Intel[®] 810 Chipset Family: 82810/82810-DC100 Graphics and Memory Controller Hub (GMCH)

Specification Update

January 2001

Document Number: 290659-003

1. Changed: GMCH Graphics Controller Register Memory

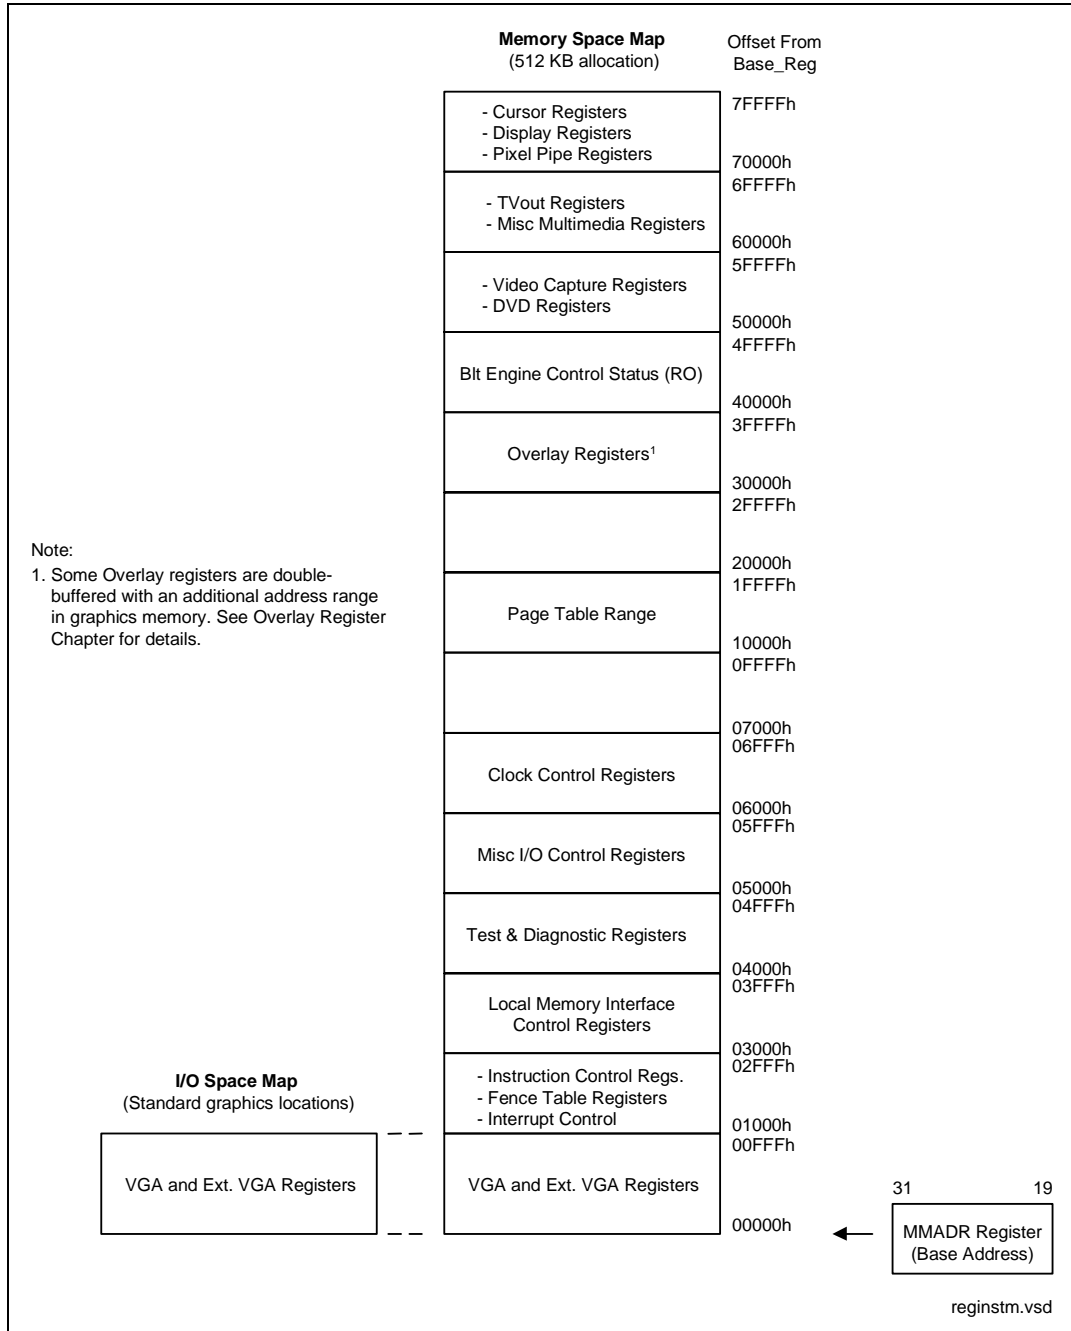
Figure 6 (*GMCH Graphics Register Memory Address Space*), Section 4.1.1.2, Extended Memory Area, is replaced with the figure below.
